APPENDIX B

Responses to NRC Requests for Additional Information (RAI) RAI-56

RAI 56**Description of Deficiency**

RAI-56 Response

Figure 1: 70 Sand aquifer time-drawdown graph showing model estimated drawdowns in active 70 Sand wellfields during project lifespan. Based on current schedule; time = 0 corresponds to beginning of year 1. Displacement is shown in meters.

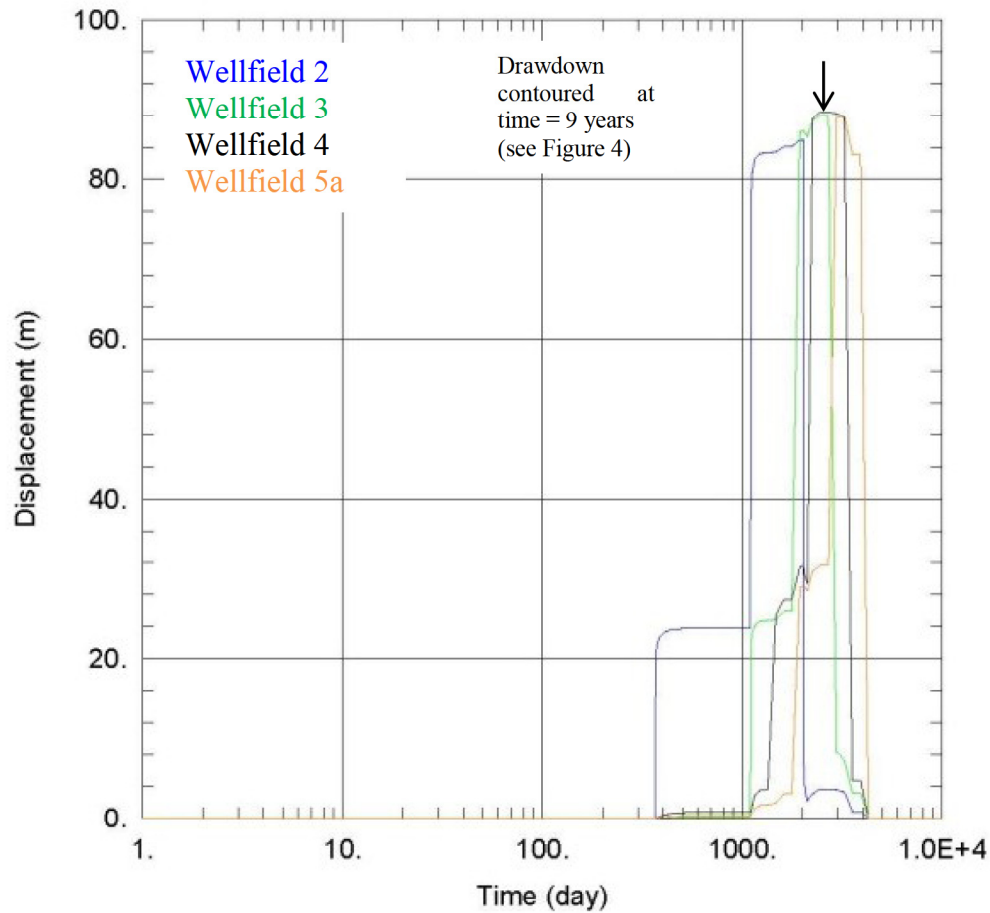
Uranium One should provide: (a) the ROI using the estimated T, S and the time of production and restoration for each satellite wellfield; and (b) a prediction of the drawdown for each satellite wellfield within 2 km for each phase of operation using the appropriate consumptive use (e.g. 15-45 gpm).

Graphs showing the modeled time-drawdown characteristics of the pumping centers in each aquifer over the duration of the project are presented on Figures 1–3. Results of the analytical drawdown modeling are also presented as drawdown contour maps on Figures 4–8. Due to the operational schedules of the 80 and 90 Sand units, two distinct drawdown peaks were noted in the model output, which correspond to unique areal drawdown patterns. Thus, individual contour maps were prepared for both the first and second peaks in these cases.
